Access Compliance Report

Public Rights-of-Way

Intersection ID: 10032938	Main Street: NEW_BERN_ST	Cross Street: N/A	Location:	N
ADA ID: F6E831F39DEF	Ramp Type: BlendTrans1	Initial Pass/Fail: Pass	Overall Compliance: No	Severity Score: 0
Codes/Mitigation Info/Possible Solution		Field Measurements/Component Compliance

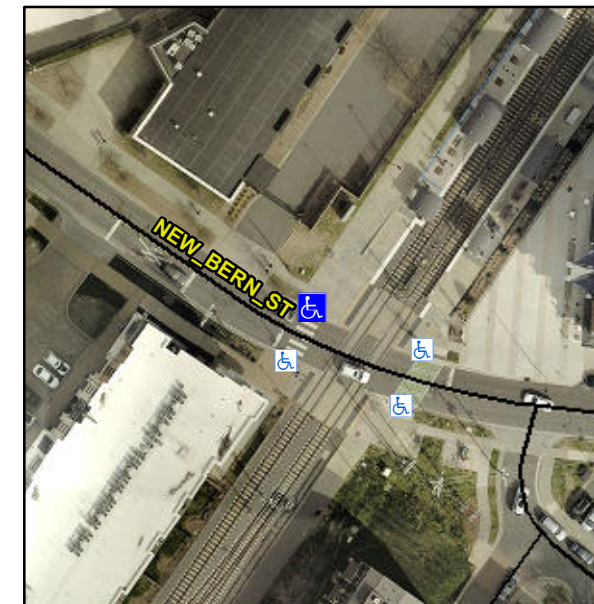
Yes	Ramp inside XWalk1?	Yes	N/A	Ramp inside XWalk2?	N/A
	Road Slope (%)	1.5		Clear Space?	Yes
	Road X Slope (%)	3.9	N/A	Clear Space to XWalk (in)	N/A
Yes	Any Obstructions?	No	Yes	Storm Grate/Utility Hazard?	No
	Obstruction Type			Storm Grate/Utility Type	
		N/A			N/A
			Yes	Surface Condition? (G/P)	Good
			No	Curb Slope (%)	20.8

Remove & Replace Curb Slope and Extend Ramp.
